# Access Compliance Report

## Public Rights-of-Way

### (Curb Ramps)

Intersection ID: 26100	Main Street: FAIRCHILD_LN	Cross Street: HOLLY_HILL_FARM_RD	Location: NW
ADA ID: 04FF353A89E7	Ramp Type: PerpDiag	Initial Pass/Fail: Fail	Overall Compliance: No
			Severity Score: 13.75

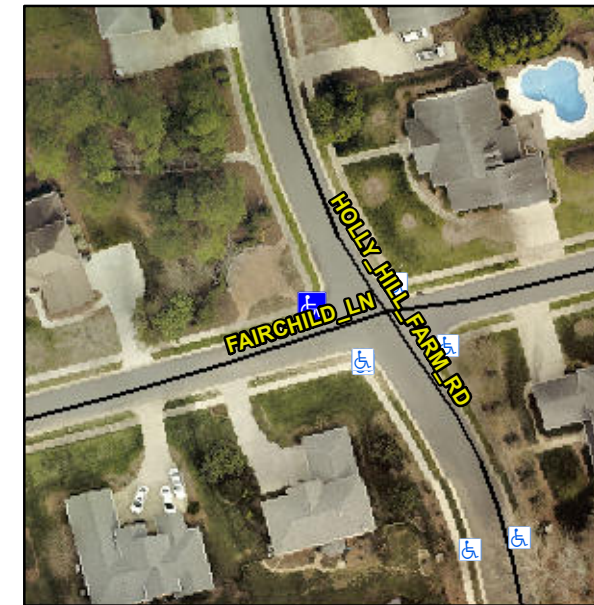
**R304.2.2, R304.5.3**

Compliance	Description	Data	Compliance	Description	Data
N/A	Ramp Length (in)	47.0	No	Ramp Slope (%)	8.7
Yes	Ramp Width (in)	48.0	No	Ramp XSlope (%)	2.5
N/A	Flare Type LT	N/A	N/A	Flare Type RT	N/A
N/A	Flare Slope LT (%)	N/A	N/A	Flare Slope RT (%)	N/A
N/A	Flare Traversable LT?	N/A	N/A	Flare Traversable RT?	N/A
N/A	Landing Length (in)	N/A	N/A	DWS Provided?	N/A
N/A	Landing Width (in)	N/A	N/A	DWS Contrast?	N/A
N/A	Landing Slope (%)	N/A	N/A	DWS Length (in)	N/A
N/A	Landing X Slope (%)	N/A	N/A	DWS Full Width?	N/A
N/A	Landing Curb? (Y/N)	N/A	N/A	DWS Offset (in)	N/A
N/A	Shared Landing?	N/A			
N/A	Gutter Ponding?	N/A	N/A	Gutter Slope (%)	N/A
N/A	Gutter Lip Ht (in)	N/A	N/A	Gutter X Slope (%)	N/A
N/A	Painted X Walk1?	No	N/A	Painted X Walk2?	No
	X Walk 1 Direction	To SE		X Walk 2 Direction	To E
N/A	X Walk 1 Width (in)	N/A	N/A	X Walk 2 Width (in)	N/A
	X Walk 1 Slope (%)	4.1		X Walk 2 Slope (%)	3.3
	X Walk 1 X Slope (%)	1.0		X Walk 2 X Slope (%)	3.4

**Remove & Replace Curb Ramp With Two New Directional Ramps or Equivalent.**
